Addendum 12: Regulation No. 13

Revision 4 - Amendment 1

Supplement 5 to the 09 series of amendments - Date of entry into force: 27 December 2000

**UNIFORM PROVISIONS CONCERNING THE APPROVAL OF VEHICLES
OF CATEGORIES M, N AND O WITH REGARD TO BRAKING**

"3. Example of a simulator for electric control lines

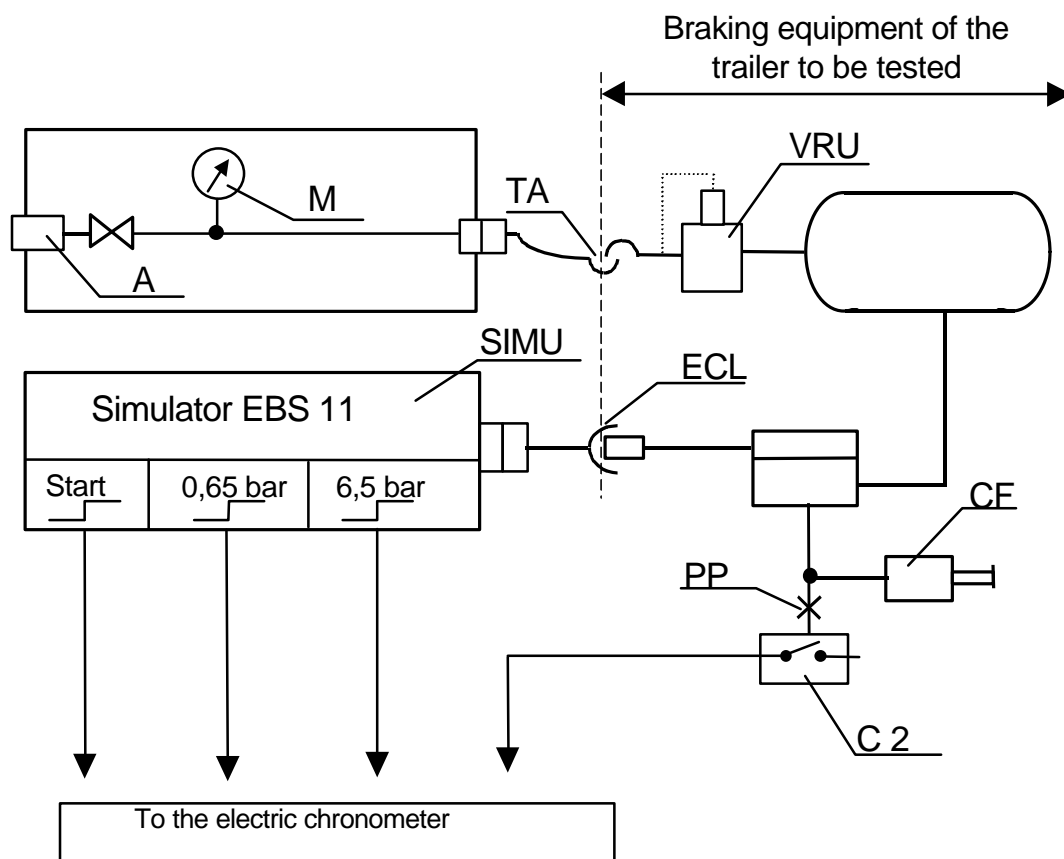
Annex 6, appendix, insert a new figure 3., to read:

ECL = electric control line corresponding to ISO 7638

SIMU = simulator of Byte 3,4 of EBS 11 according to ISO 11992 with output signals at start, 0.65 bar and 6.5 bar."
